**RE: Green Ridge Recycling and Disposal Facility, LLC
SWP 626
Notice of Intent and Part A Application – Addendum to Technical Review 2 (10/25/2022)
Response to Technical Review 2 Addendum
DAA Job Number: 18020117-090102 (TRC 17319)**

**Subject: Green Ridge Recycling and Disposal Facility, LLC
Notice of Intent and Part A Application – Addendum to Technical Review 2
(dated June 16, 2022)**

Figure 1 – Overall Site Layout

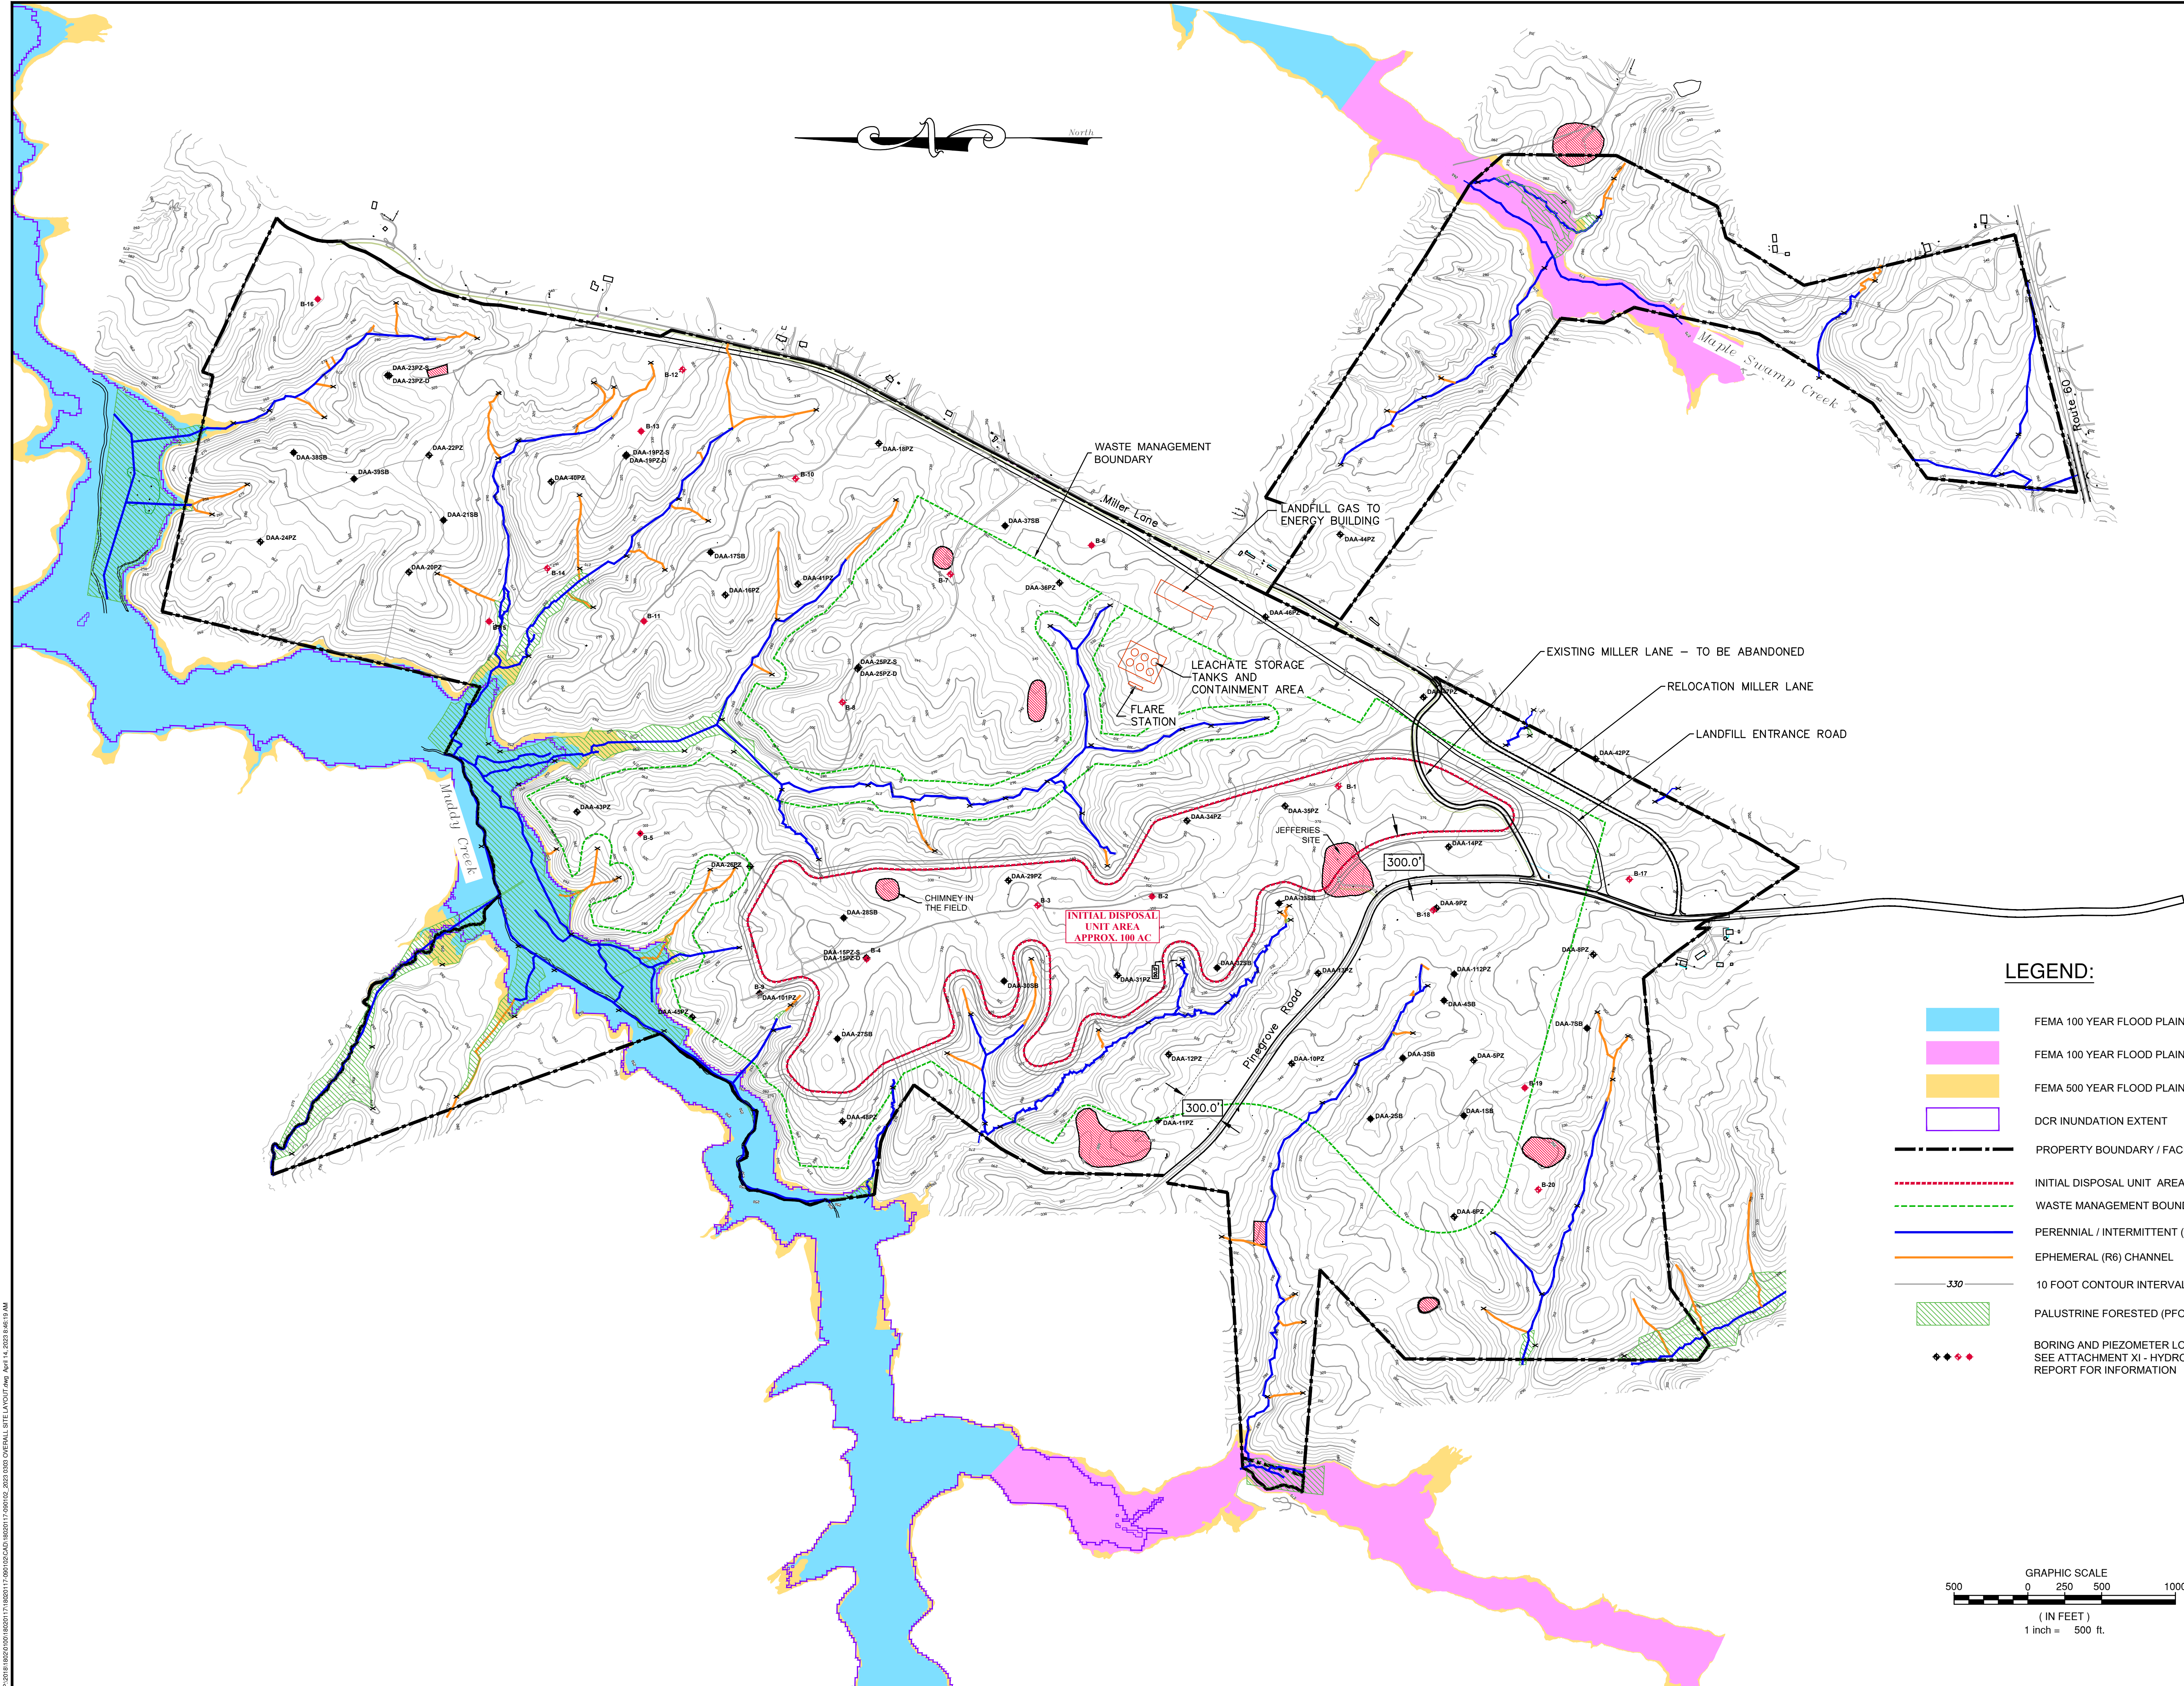
The Virginia Department of Environmental Quality (DEQ) Piedmont Regional Office (PRO) solid waste program is coordinating its review of the Notice of Intent (NOI) and Part A Permit Application for the Green Ridge Recycling and Disposal Facility, LLC, with the Virginia Water Protection (VWP) program staff. Based on review of the Joint Permit Application (JPA) received by the VWP program, the proposed project will impact perennial stream resources located within the area of proposed disposal units. It appears that these streams within the disposal area are fed by springs or groundwater seeps.

*The Virginia Solid Waste Management Regulations (VSWMR, 9 VAC 20-81-10, et seq.) siting requirements as specified in 9 VAC 20-81-120.C.1.b. state, “**No disposal unit or leachate storage unit shall be closer than: ... 100 feet from any perennial stream or river.**” Additionally, 9 VAC 20-81-120.F.1.c. states, “**Certain site characteristics may prevent approval or require substantial limitations on the site use or require the incorporation of sound engineering controls. Such site characteristics shall be identified and an explanation of precautions necessary to assure compliance with the provisions of this chapter shall be provided. Examples include:...Springs, seeps, or other groundwater intrusion into the site;...**” The Part A Application Form, and portions of the NOI and Part A Permit Application, indicate that the distance from proposed disposal units or leachate storage areas to any perennial stream or river is 100 feet, and there are no springs present.*

Response: As has been reviewed with DEQ, Green Ridge has reconfigured the initial disposal unit area. Figure 1, which was prepared for the TR 2 response and is included herein as **ATTACHMENT 02**, illustrates the proposed initial disposal unit area. The initial disposal unit area will not impact wetlands or streams that would require a permit from ACOE or the DEQ VWP program. This includes consideration of both primary and secondary impacts. Hence, the JPA was withdrawn on _____ and the Part A has been updated accordingly.

Response: The initial disposal unit area meets the siting requirements of VSWMR 9 VAC 20-81-120.C.1.b.
